City of Westminster

Addendum #2

Inflow & Infiltration Rehabilitation Project Phase 3 (Design-Build)

RFB # 21-03

Client: **CITY OF WESTMINSTER**
Project: **SEWER INFLOW INFILTRATION REHAB PROJECT PH II**
Title: **AREA 2 SEWER PIPELINE PLAN AND PROFILE 1**

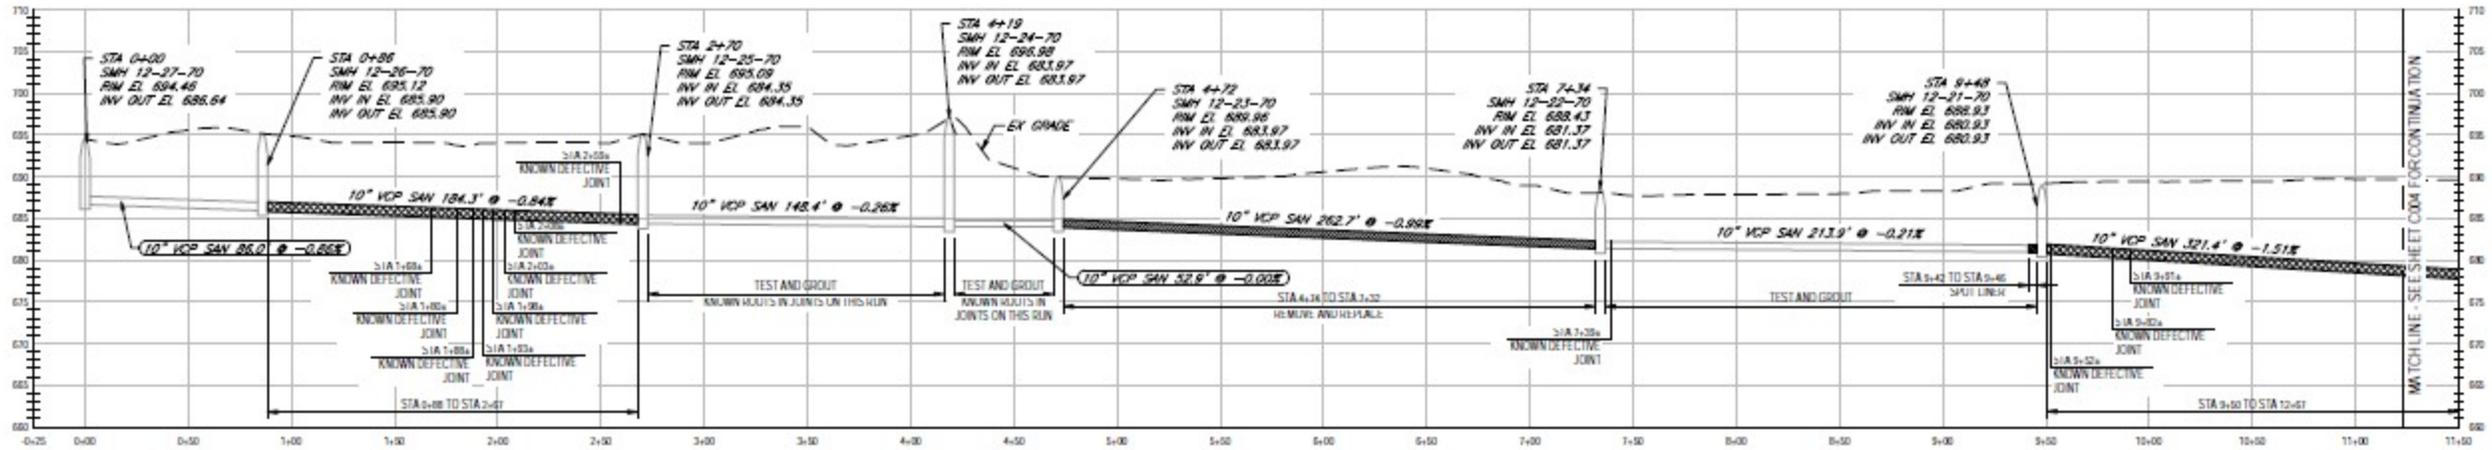
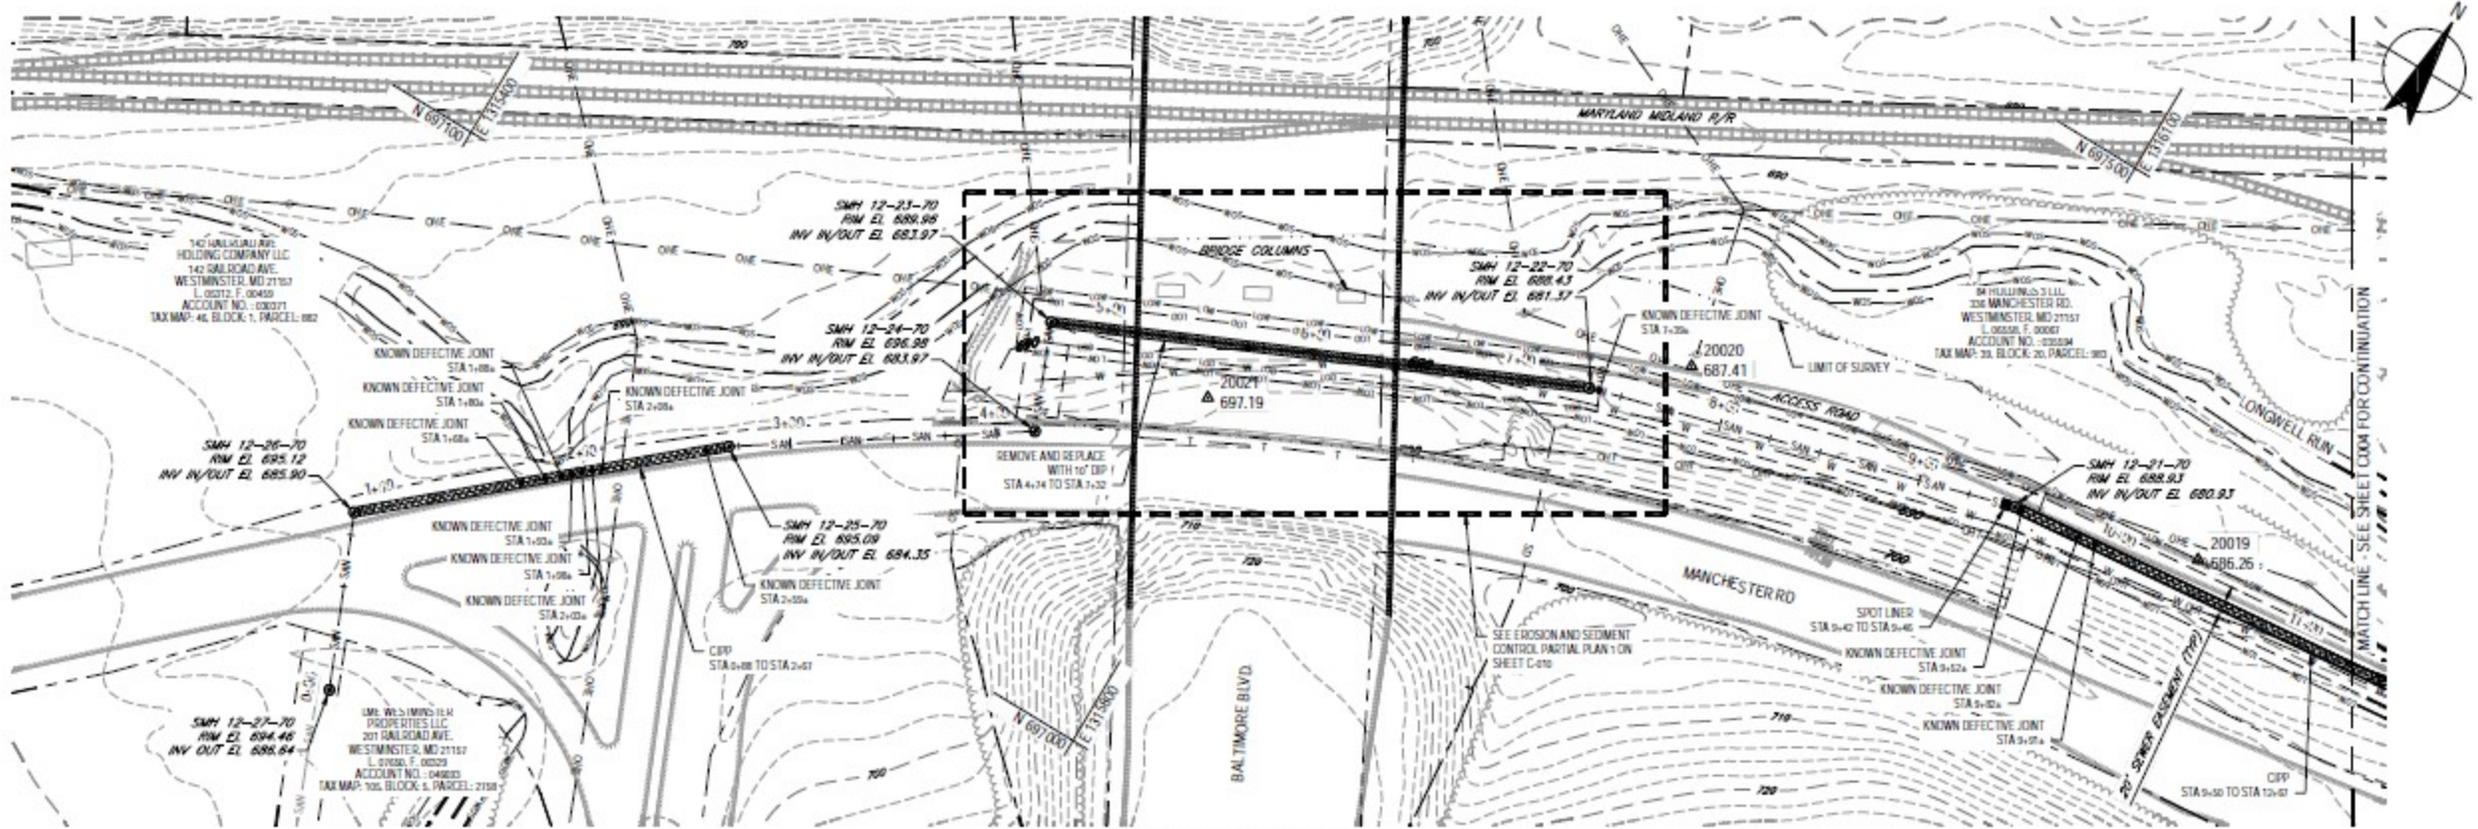
13. Question: Can the City provide a set of drawings (PDF) from the last built sewer phase to ensure understanding of drawing detail and City's drawings expectation?

Answer: Yes, see attached drawing.
